PD Modification Application: PRS 23-0510

Applicant: Wal-Mart Stores East, LP

8.0 SITE PLANS (FULL)

Walmart
MINOR MODIFICATION GENERAL SITE PLAN
1208 E BRANDON BOULEVARD, BRANDON FL

2.3 Approved Site Plan (partial provided below for size and orientation purposes. See Section 8.1 for full site plan)

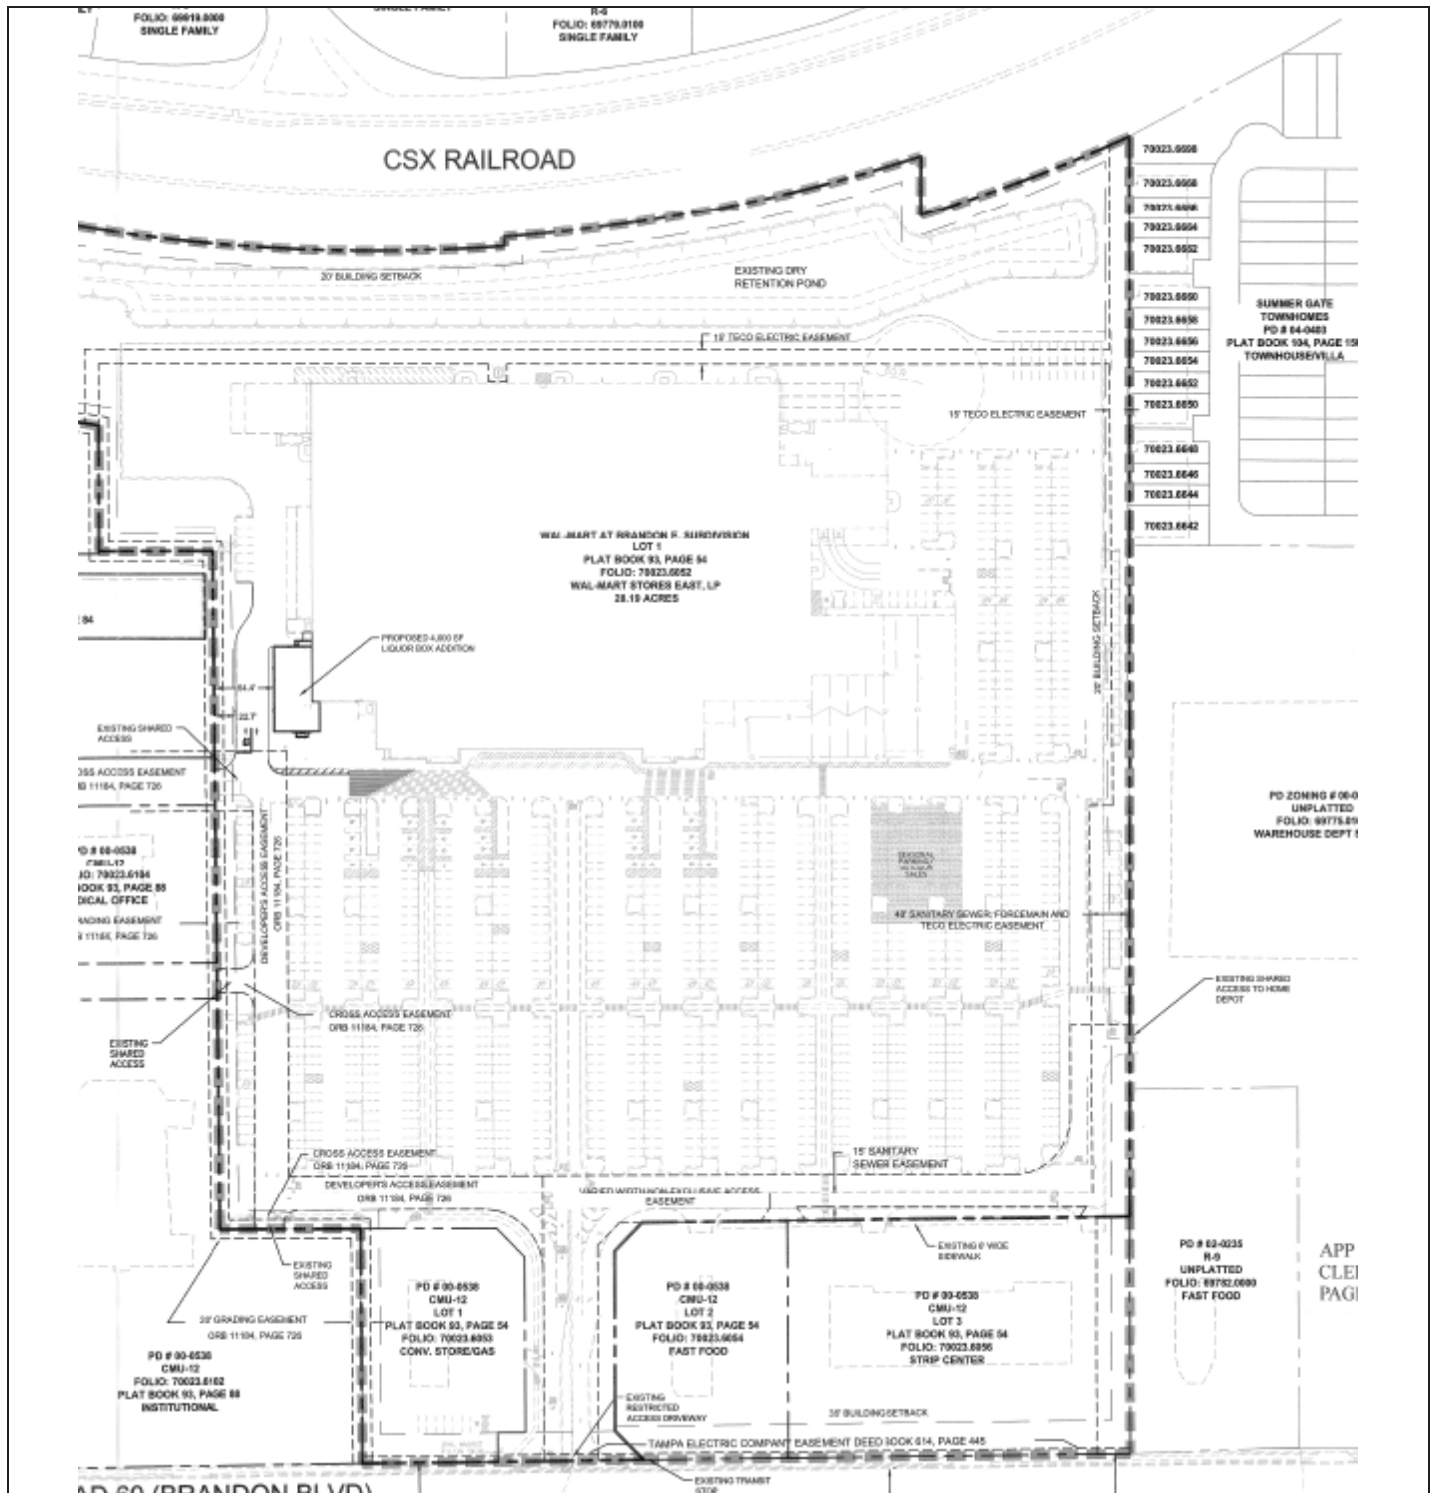
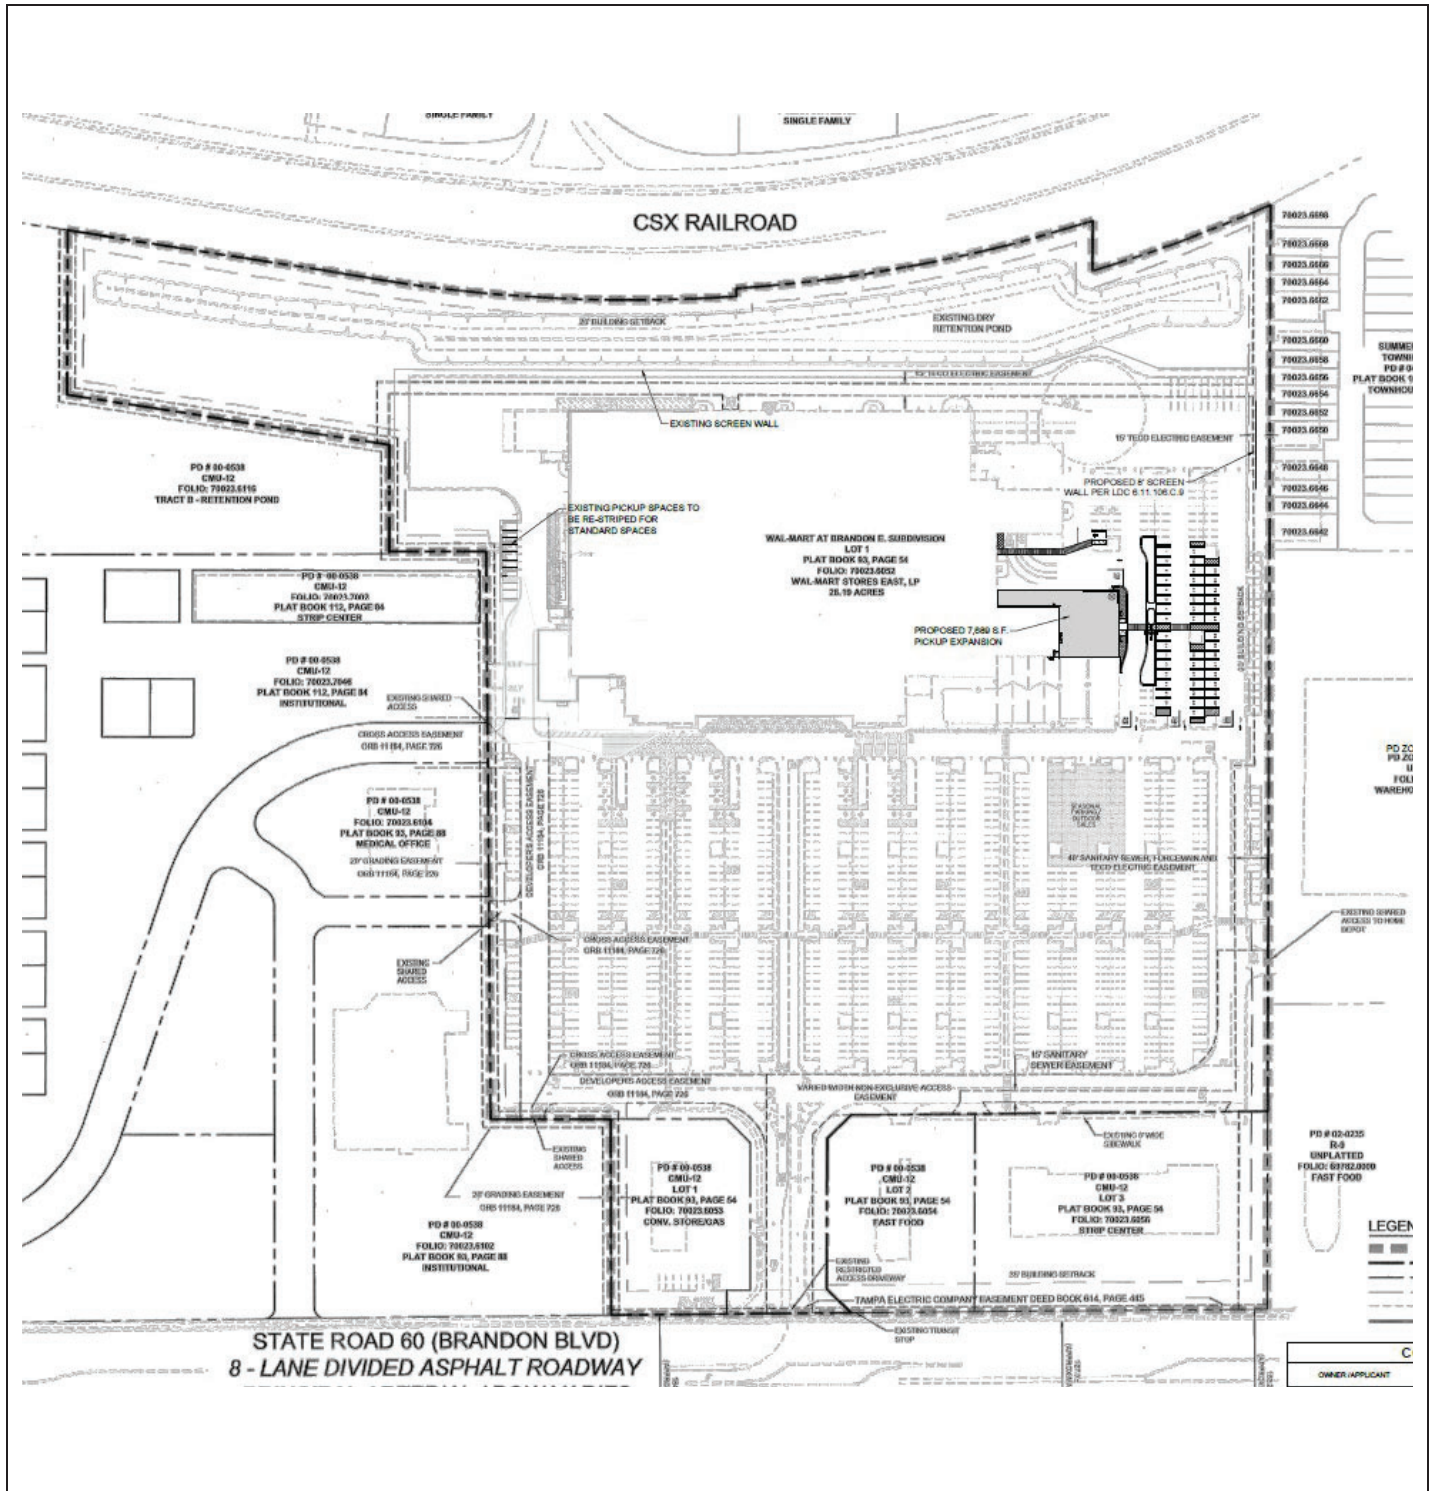
PD 00-0538 was approved in 2001 to allow for a mix of retail, residential, lodging, recreational, self-storage, and assisted living uses over five parcels. Within PD 00-0538, Parcel A was approved for up to 205,350 square-foot (SF) of big box retail with a 20,800 SF garden center, a 600 SF gasoline station, and up to 30,000 SF of additional retail to be located on no more than three outparcels. The applicant requests modifications to Parcel A to allow for a net increase of 7,689 SF to accommodate online grocery services for their customers. The modification would also include a reduction in parking and a reduction in garden center gross floor area (GFA).

PD Variation(s):	LDC Part 6.05.00 (Parking/Loading) Reduce required parking from 4.25 to 3.98 spaces per 1,000 SF of GFA
Waiver(s) to the Land Development Code:

The proposed variation to reduce the minimum number of parking spaces to 3.98 spaces per 1,000 SF is supported by a parking study that the County Engineering Department found approvable. The plans proposed an 8-foot-tall screen wall that would screen the existing loading area and part of the additional floor area from the neighboring residential property. Staff finds the impacts of the additional gross floor area to accommodate the proposed customer pick up service compatible with the surrounding development pattern.

Approval - Approval of the request, subject to the conditions listed below, is based on the general site plan submitted ~~June 17, 2014~~ August 24, 2023.
